MEMO

RE Bear lakes Properties Well Permit No. 123-33944
Class II Disposal Well application to inject waste into an underground formation for disposal
Bittering No. 2 Columbus Township, Warren County

TO S. Craig Lobins
FROM Bruce E. Jankura, P.E. 
DATE May 25, 2017
RE Bear Lakes Properties
Warren County, Bittinger #2
Mechanical Integrity Review
EPA UIC Application Documents

RE Bear Lake Properties, LLC – Warren County, Joseph
Bittinger Well #2
Geological Review
EPA UIC Application Documents

Figure 1. Conventional wells with the quarter-mile and one-mile buffers depicted (the inset status classifications only apply to Pennsylvania wells).

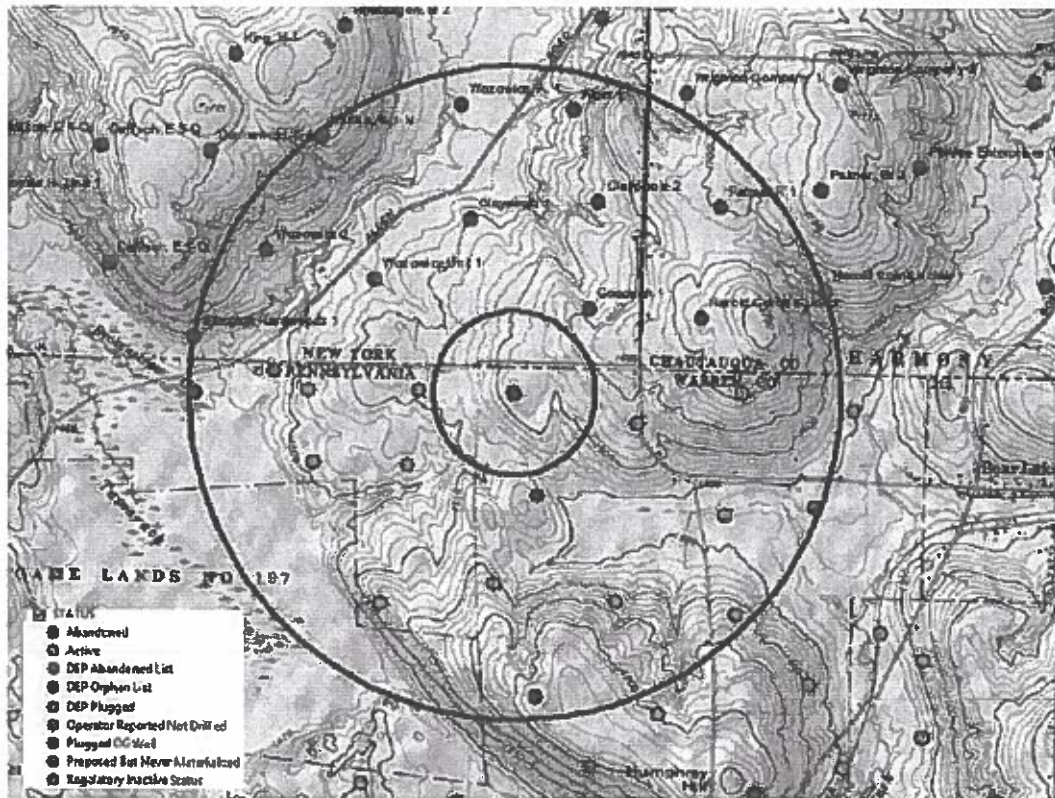
The Department's review of operating and plugged wells within a quarter-mile radial distance confirmed the information provided by Bear Lake in their application that there are no operating wells that penetrate the injection horizon (Figure 1). Within a one-mile radial distance, Bear Lake did not identify two wells located in New York State, one is located approximately 0.85 miles to the northeast of the site and the other is located approximately 1 mile east-northeast of the site. The first well is labeled as the Palmer R 1 well (API# 31-013-20944-00-00) and the company is listed as Empire Energy E&P LLC. New York's data indicate the well as being completed on 12/15/1987 to a depth of 4,595 feet. The second well is labeled as the Harold Cornish Unit 1 well (API #31-013-19262-00-00) and the company is listed as Rex Energy 1 LLC. Available data indicate the well as being completed on 10/31/1984 to a depth of 4,581 feet. Both wells target the Medina Group as the production zone. A total of twenty-one (21) active wells (9 in Pennsylvania and 12 in New York) were located within the one-mile radial distance of review. All of these wells target the Medina Group as the production zone.

A plugged well, API# 123-41380, E. Cafilisch 1 (the Department's eFACTS operator is listed as Empire Exploration Inc.) is located 0.99 miles west of the site. This well was plugged in September 1992 and the plugging certificate was approved by DEP in November 1992. Sand, a mechanical bridge plug and seventeen (17) sacks of cement were used to plug the gas-bearing zone from 4,000 feet to 4,305 feet (Figure 1).

Two abandoned wells have been identified within the mile radial distance of the proposed site. The first abandoned well (API #123-34843, identified as the Smith Ras Unit 1) is owned by Bear Lake Properties, LLC and will be used as a monitoring well for the proposed injection well. This well is located approximately 0.33 miles south of the site. The second abandoned well (API #123-33834, identified as the W W Hammond Jr 1) is owned by Bear Lake Energy (listed in eFACTS as OGO-67220, which is different than OGO-67770 for Bear Lake Properties, LLC). This well is located approximately 0.93 miles south of the site (Figure 1).

Figure 2. Faults located near the proposed well site.

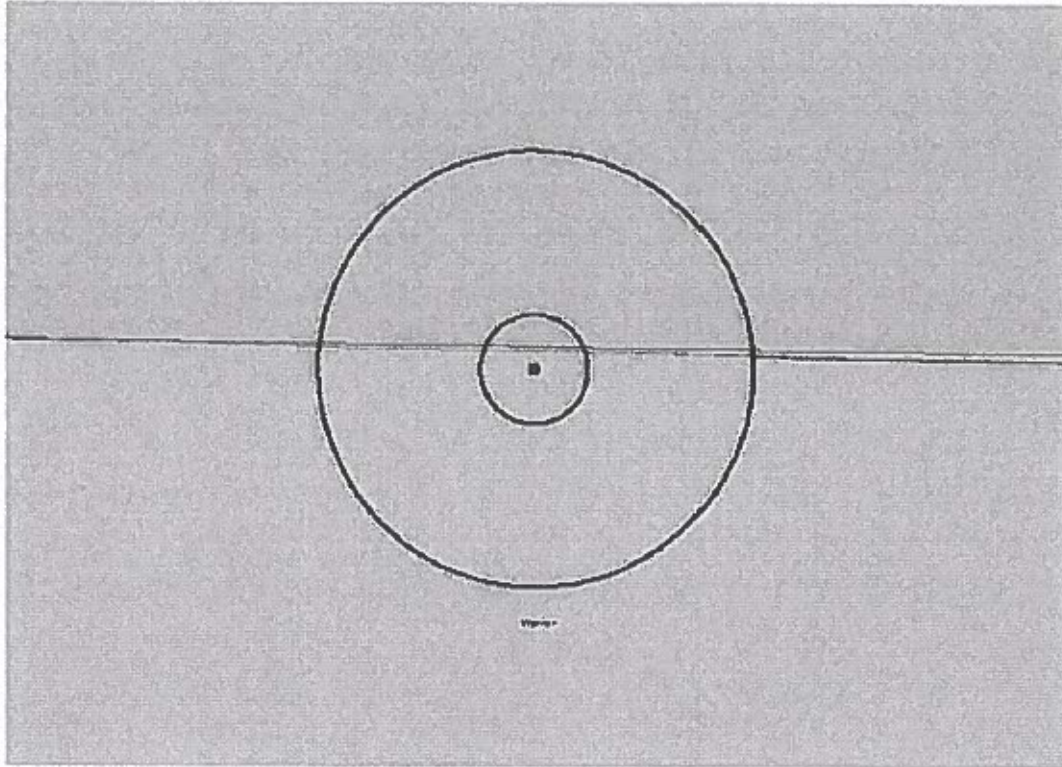
The Department's review indicates there are no mapped faults or structural fronts in the quarter and one (1) mile areas of review (Figure 2). In the application to EPA under "Potential for Faults and Seismicity", Bear Lake correctly notes that no faults are identified in the vicinity of the proposed wells site. The nearest fault identified in Pennsylvania or New York is over 25 miles to the southwest of the site.

Figure 3. Seismic activity map showing 3-mile buffers around Magnitude 2 or greater earthquakes.

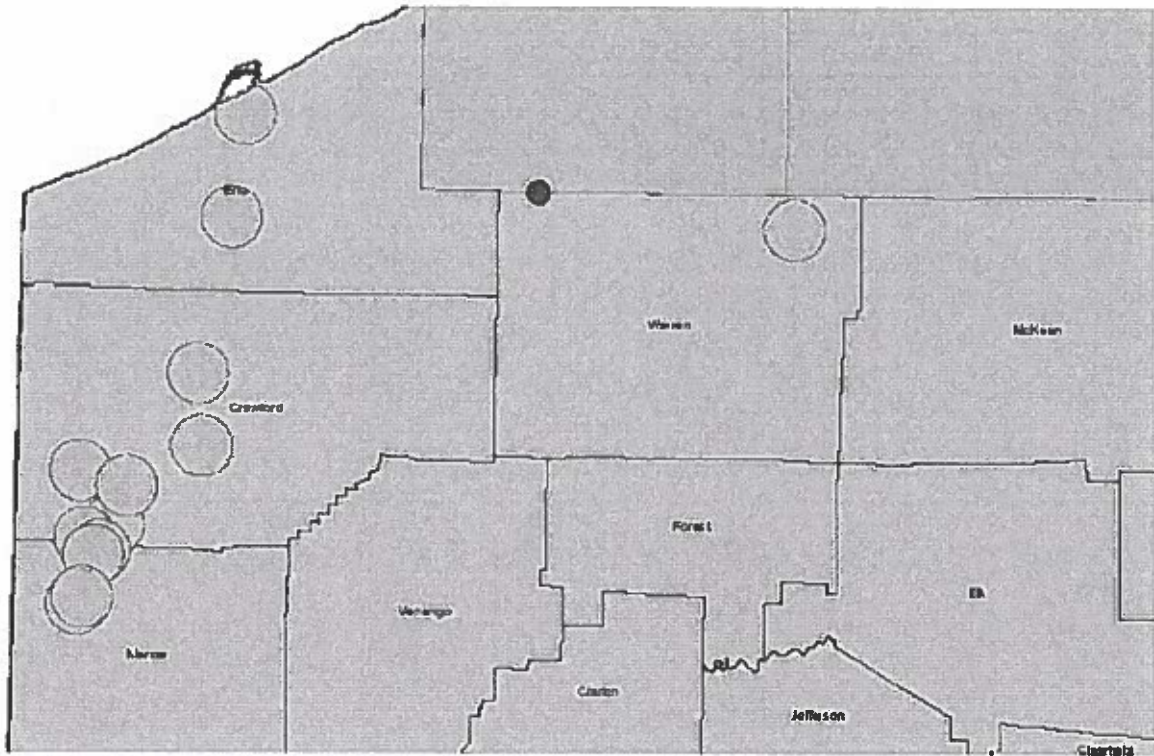
The Department's review indicates there are no historical seismic events within the quarter- and one-mile radius area of review (Figure 3). There is one earthquake of 2M or greater identified within Warren County. This earthquake was identified on Pennsylvania's Department of Conservation and Natural Resources (DCNR) Map 69, *Earthquake Catalog and Epicenter Map of Pennsylvania*. The epicenter of this earthquake is over 25 linear miles from the proposed well site.

Figure 4. Depth to Precambrian crystalline basement rock. UIC well site (red circle)

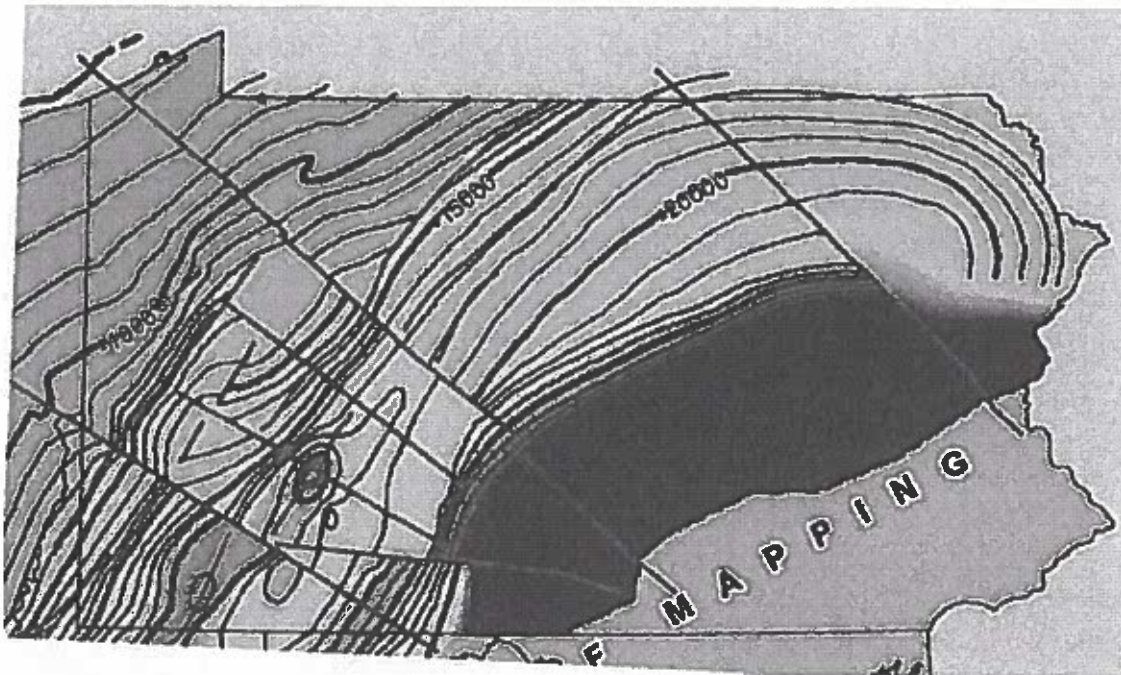
It should be noted that EPA reports induced seismicity associated with injection wells in Ohio resulted from injection into Precambrian basement rock. These rocks are often cross-cut by blind faults and are crystalline in nature. Additional studies by the State of Oklahoma (<http://earthquakes.ok.gov/>) and within the geologic community appear to corroborate the belief that injecting fluid into brittle, crystalline basement rock can result in induced seismicity. The Department reviewed maps showing the basement rock (depth of approximately 7,000 feet to 8,000 feet) and the injection zone (depth of 4,246 feet to 4,427 feet) for this well and identified a separation distance of approximately 2,500 to 3,500 feet (Figure 4)

Figure 5. Map showing storage well and storage field locations (gold dots). Quarter-mile and one-mile buffers depicted.

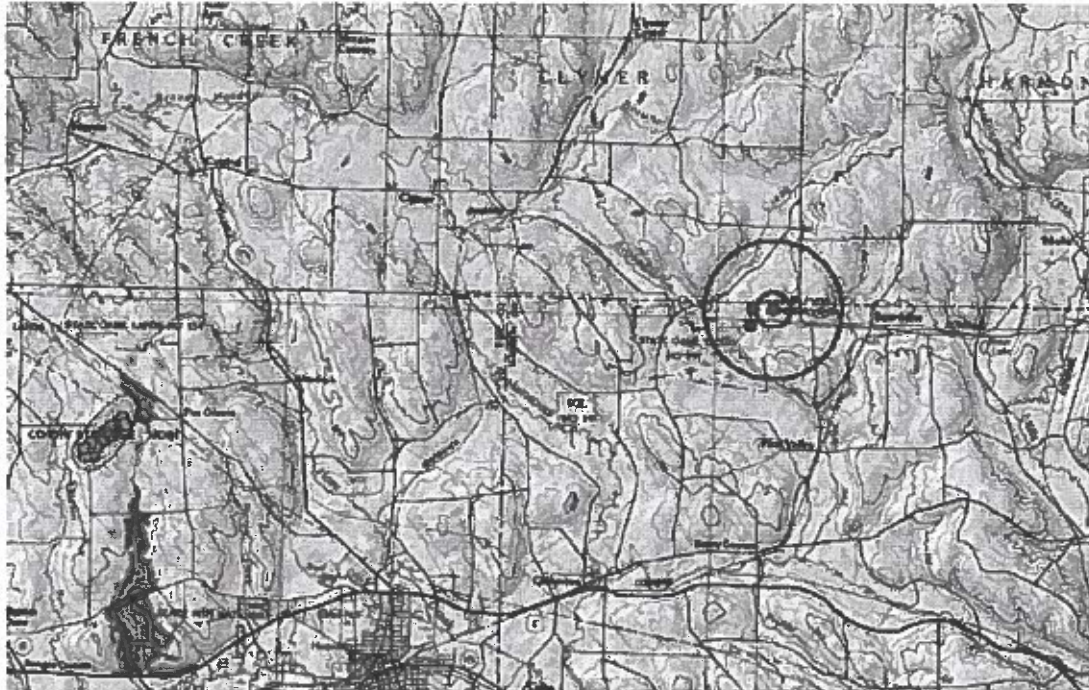
The Department's review indicates the closest storage wells are located approximately 9.5 miles west-southwest of the proposed injection well site. This site is the location of an active storage field (Corry) (Figure 5). Since the Corry Storage Field is over 9 miles from the site, and outside the $\frac{1}{4}$ mile radius of review, it is not expected to be affected by injection activities. The Department's review indicated two waste injection wells within the one-mile radius of review. These wells are currently operated by Bear Lake and are discussed in the EPA application for the proposed well.

Figure 6. Map showing surface and underground mining activities in the area. Quarter-mile and one-mile buffers depicted.

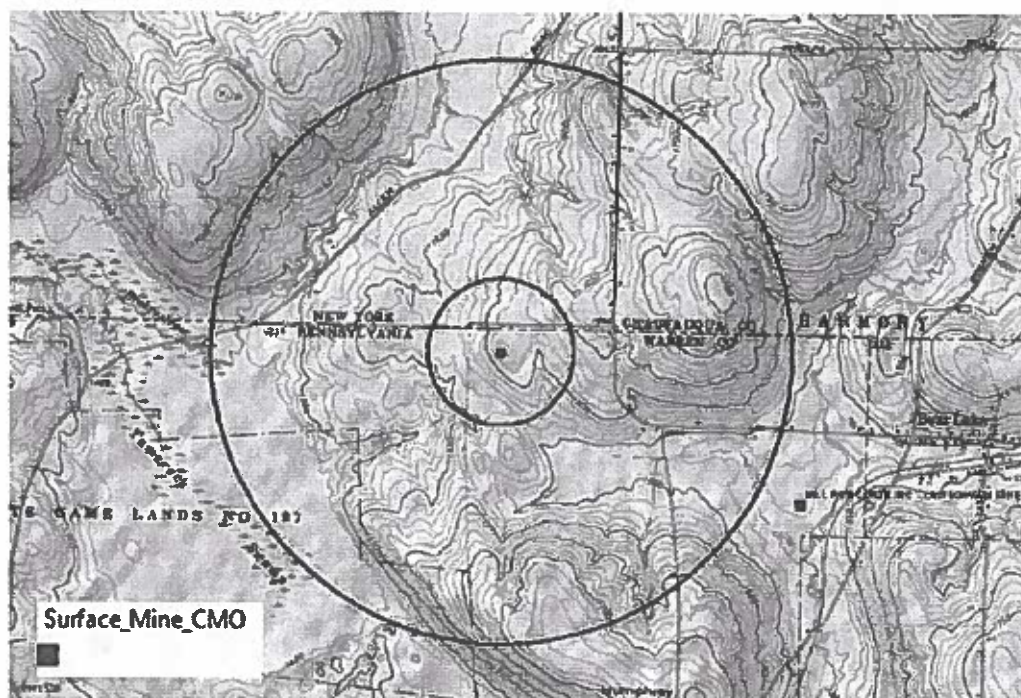
The Department's review indicates there is no surface or underground mining within the quarter- and one-mile radius area of review (Figure 6). One surface mine (Lawsonham mine) is located approximately 1.15 miles east southeast of the proposed injection well site. This surface mine is listed as a coal mining operation (CMO).

Figure 7. Map showing private and public water supply wells Quarter-mile and one-mile buffers depicted.

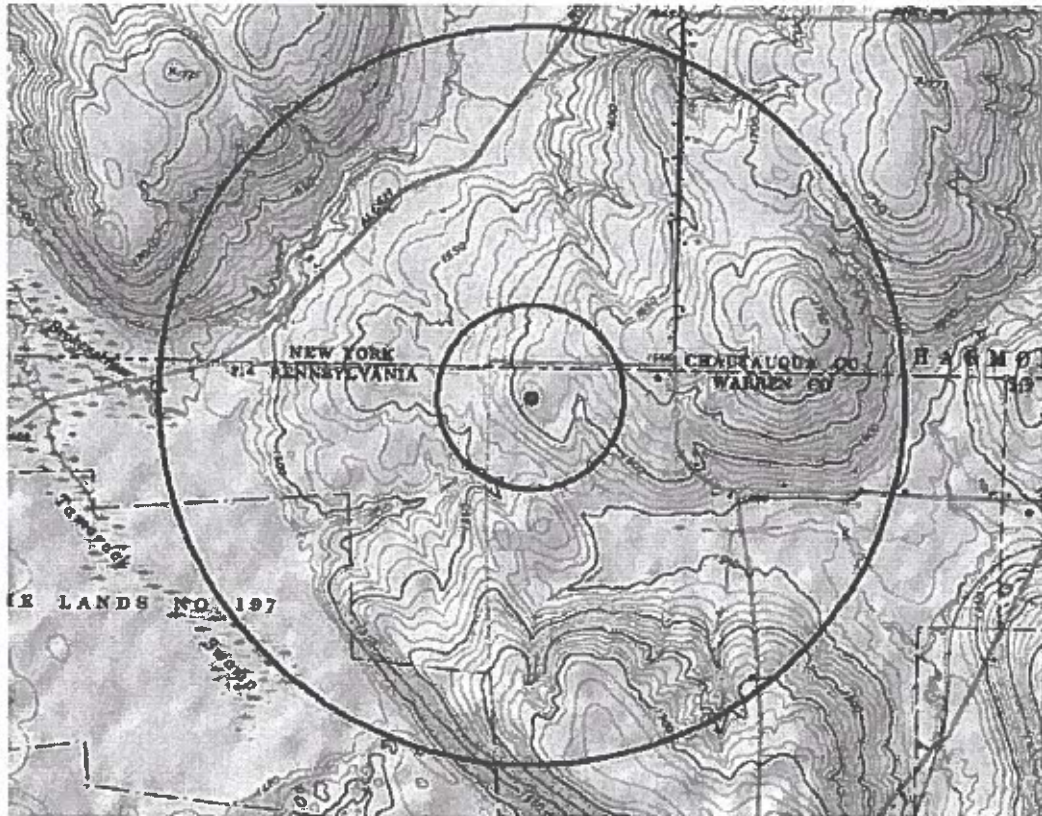
The Department's review indicates there are no active municipal water wells within the 1-mile radius of review; however a private, domestic water well was found within this review area. The domestic water well is located approximately 0.34 miles east northeast of the proposed injection well site (Figure 7). Details of this private water well were provided in Pennsylvania Groundwater Information System (PaGWIS). The water well, which was drilled on December 1, 1993, extends to a depth of 86 feet with bedrock being located at a depth of 10 feet. The PaGWIS information also identifies Reepu Singh as the well owner. This well is located on what is now identified as Bear Lake's property in Appendix A of the application. In Bear Lake's application to EPA, they correctly indicated there are no water wells within the quarter-mile area of review. Section 4 of the application contains a discussion of the depths to underground drinking water sources (USDW). The information supplied by Bear Lake within the application as it relates to depths of USDW corroborates the data obtained in PaGWIS that the deepest used supplies of drinking water are less than 300 feet below existing grades.

- It is recommended that the location, depth and use of any additional private, domestic or other water wells be confirmed by the Department.
- Once the location, depth and usage of the aforementioned wells are confirmed, the Department must take steps to ensure the casing and cementing design of the proposed injection well satisfies the requirements of 25 Pa. Code Chapter 78, Subsection D.

Once the location, depth and usage of the aforementioned wells are confirmed, the Department should ensure the casing and cementing design of the proposed injection well satisfies the requirements of 25 Pa. Code Chapter 78, Subchapter D by completing an engineering assessment of the well's construction characteristics and integrity. If no issues are noted during the review, it is my professional opinion that there is no expected risk to surrounding water supply wells provided injection well integrity is maintained per the requirements of EPA's UIC Program. This belief is due to the required construction of the well, the geology, and the distance of these features to the well and its injection horizon.
